DRC Meeting Minutes: July 30, 2018

Sign Design Review for Irving Gas, 71 Main St.

DRC Sign Design Review Planning and Economic Development Office Comments July 27, 2018

Sign Location Address: 71 Main Street

AFP CANOPY GRAPHICS | LAYOUT

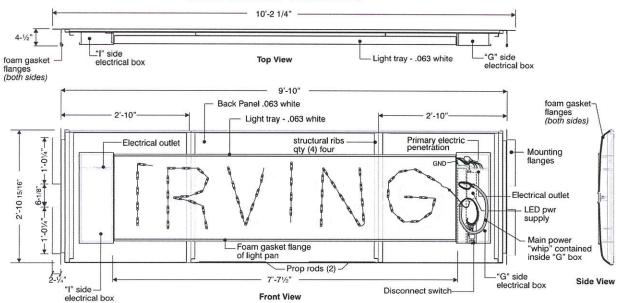
- To reface the canopy fascia with new white backer panels and blue AFP (aluminum formed panels) that will not be illuminated. The Irving text and red chevron logo will be illuminated. The horizontal red rope light will not be illuminated. Members were concerned that the business might consider illuminating the red rope portion of the canopy sign in the future and it should be clear that is not allowed.

- Mr. Gary Bolduc (sign installer from Poyant Signs) arrived at the meeting around 7:27PM. NOTE - The sign company representing Irving Gas is based out of Ohio so Mr. Bolduc attended in their place. Mr. Buckley stated the DRC's concerns regarding the illumination of the new canopy sign. The DRC acknowledges that it's a pre-existing condition but asked the applicant to consider not installing any illumination behind the red horizontal ribbon portion of the sign.

- 1. This proposal provides for only 1 Irving sign/chevron on the north face of the canopy instead of the existing two signs, one on the east and west facades.
- 2. Only the white Irving text and the red chevron are to be internally illuminated. The blue and white background panels and the thin red horizontal stripe are not illuminated.

MAIN ID | PHOTO RE-IMAGE | OPTION 4

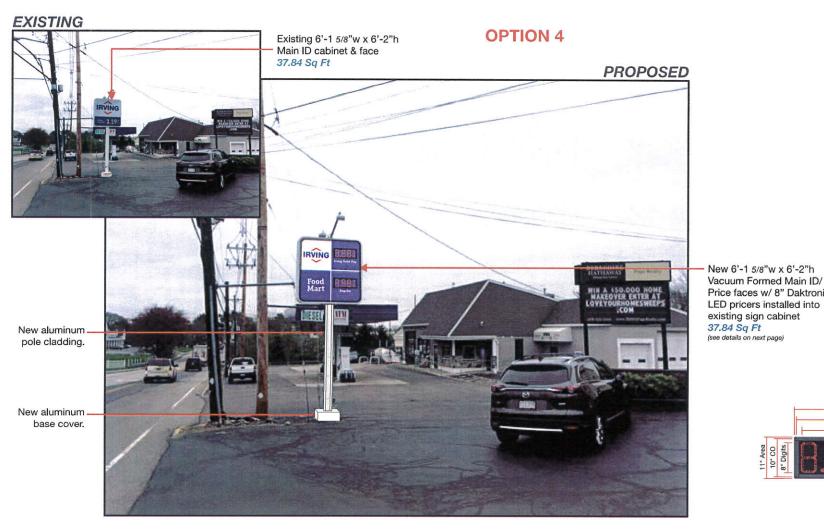
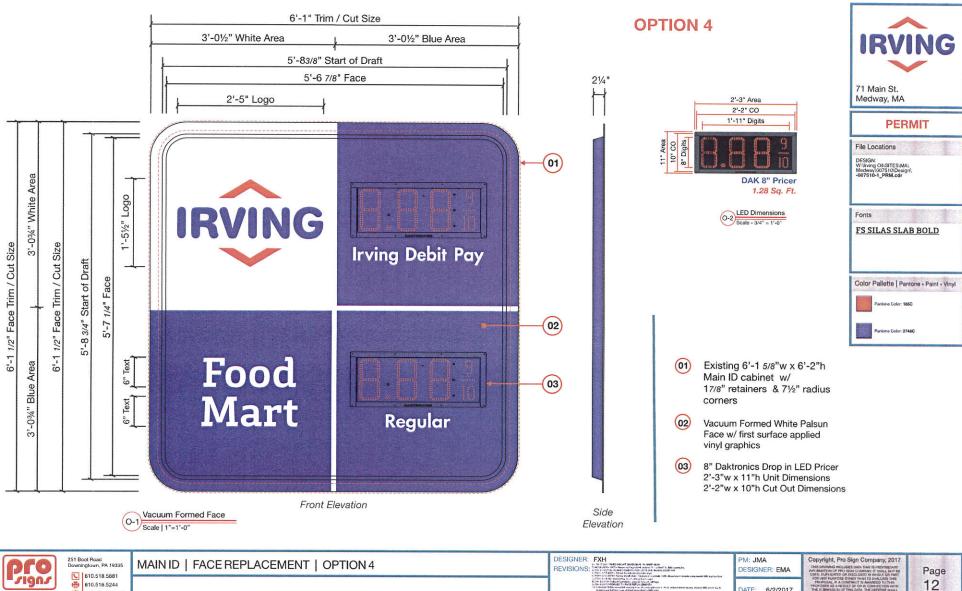
- To retrofit the existing free standing sign cabinet with new faces and reuse the existing pole and foundation. There will be aluminum cladding and an aluminum base cover added to the pole and base that will not be illuminated.

- No landscaping at the base of the sign is proposed at this time. With new aluminum pole cladding and base cover being proposed, DRC members said there's an opportunity for the applicant to have some planters around the pole.

- There was discussion on the format of the proposed new sign faces that have the business name and gas prices included.
- Members recommended that the existing "Diesel" and "ATM" signs should come off the pole sign.

- 1. The existing free-standing pole sign is non-conforming to Medway's current sign regulation section of the Zoning Bylaw in terms of its height and the amount of sign surface area.
- 2. The proposed sign does not increase the non-conformity as the existing sign cabinet and pole are being retrofitted.
- 3. The proposed 8" LED illuminated gas price letters comply with the Bylaw in terms of amount of sign surface area.
- 4. The existing pole and base will be clad in new white aluminum to give it a fresh look.
- 5. Landscaping is required around the base of a free-standing sign 3 feet in all directions. That has not been provided.
- 6. Remove the Diesel and ATM signs hanging off either side of the pole.
- 7. Will the existing exterior lights continue to be used? Or will new light fixtures be added?

- A recommendation for a new monument sign that fits the normal style of architecture and complies with the Zoning Bylaw and the Design Guidelines will be made. Letter will also include a preamble recommending that the signs be brought into compliance.
 Applicant will be asked to implement landscaping around the base of the pole that could act as a protective barrier.
